LODGE PROPERTY
PRELIMINARY OVERALL DEVELOPMENT PLAN

CITY OF SAN ANTONIO
APPLICATION FOR A PRELIMINARY OVERALL AREA
DEVELOPMENT PLAN (POADP)

Re: Lodge Property

POADP # 492

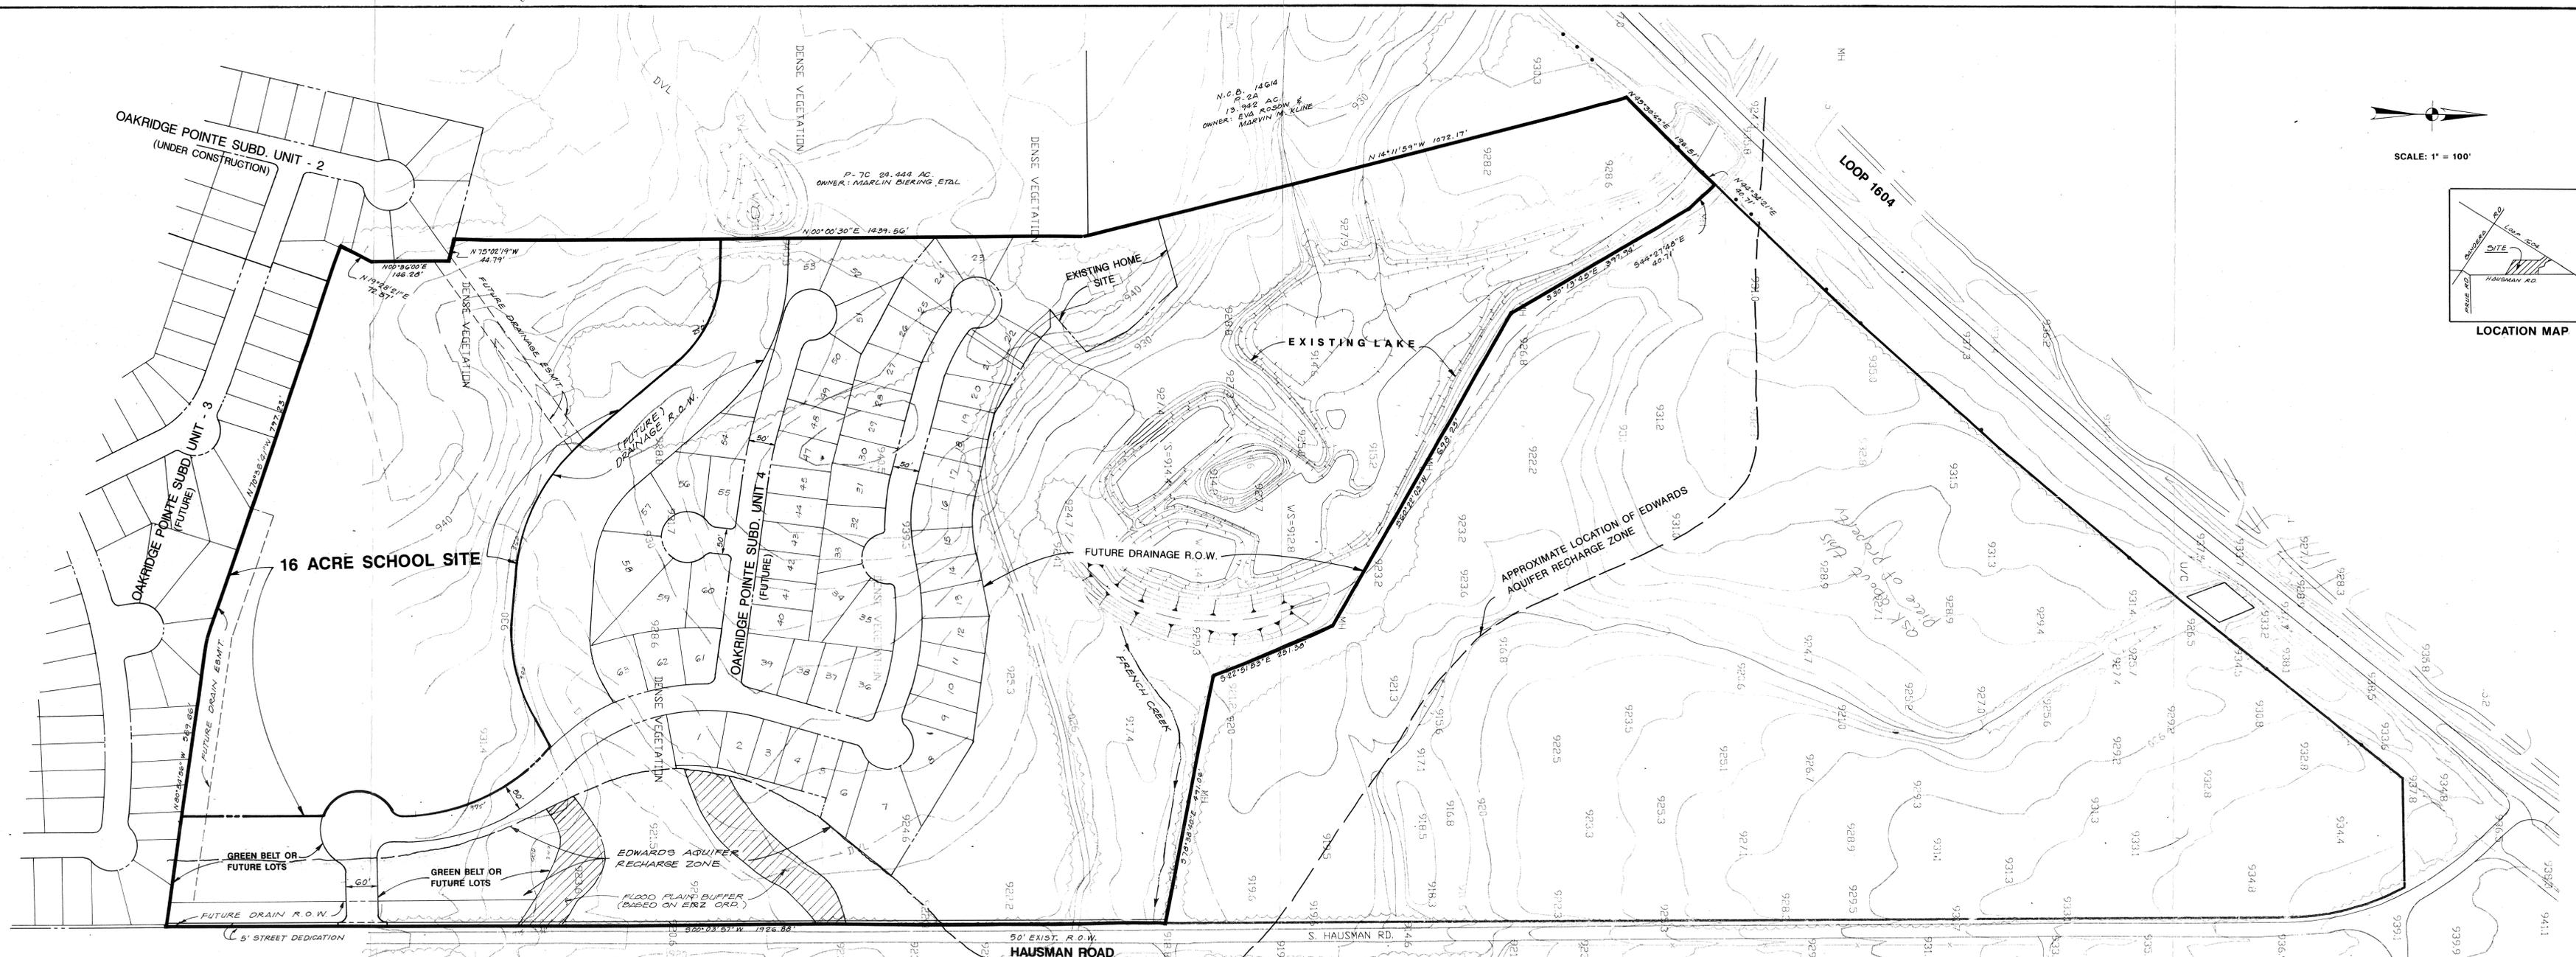
1. It is our understanding that bicycle and pedestrian access will be provided between the school and the adjacent properties to the west and north.
2. Based on the topography, a Flood Plain Study will probably be required.
3. This development will probably need to conform to requirements associated with development over the Edwards Aquifer. For additional information about these requirements you can contact SAWS at 704-7305.
